"The Rize": 228 – 246 east broadway & 180 kingsway, vancouver  
CD-1 Public Hearing: Rezoning Application/february 2012

**Public Hearing Submission:**

Re: Rezoning Application

Public Hearing: february 2012

Part IV Analysis:  
 the "square"  
 donut

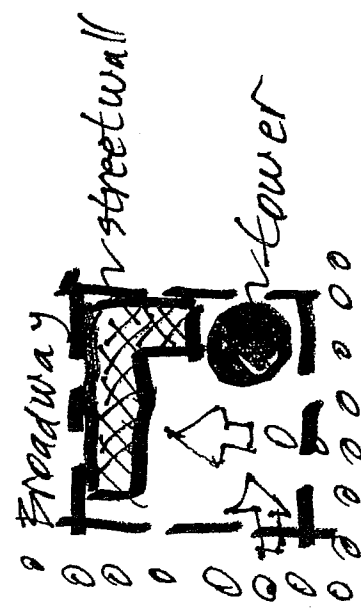
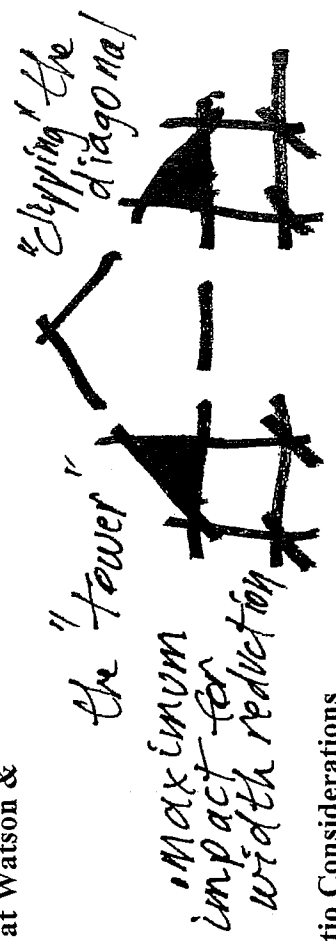
A permeable site

-- development of a 10<sup>th</sup> Avenue public plaza/open/green space on the north side of 10<sup>th</sup> Avenue - capturing south light & enhancing the 10<sup>th</sup> Avenue bikeway & pedestrian walk;

-- design with falling topography from 10<sup>th</sup> Avenue to Broadway for potential stepping plaza/open space/pedestrian route from 10<sup>th</sup> to Broadway;

-- maximum 30 ft. streetwall scale on Broadway & Kingsway;

-- elimination of westerly residential mid-rise on Watson to open potential public plaza/open space/roof deck to direct westerly light and eliminate potential conflicts with four-storey residential apartment at Watson & 10<sup>th</sup>;
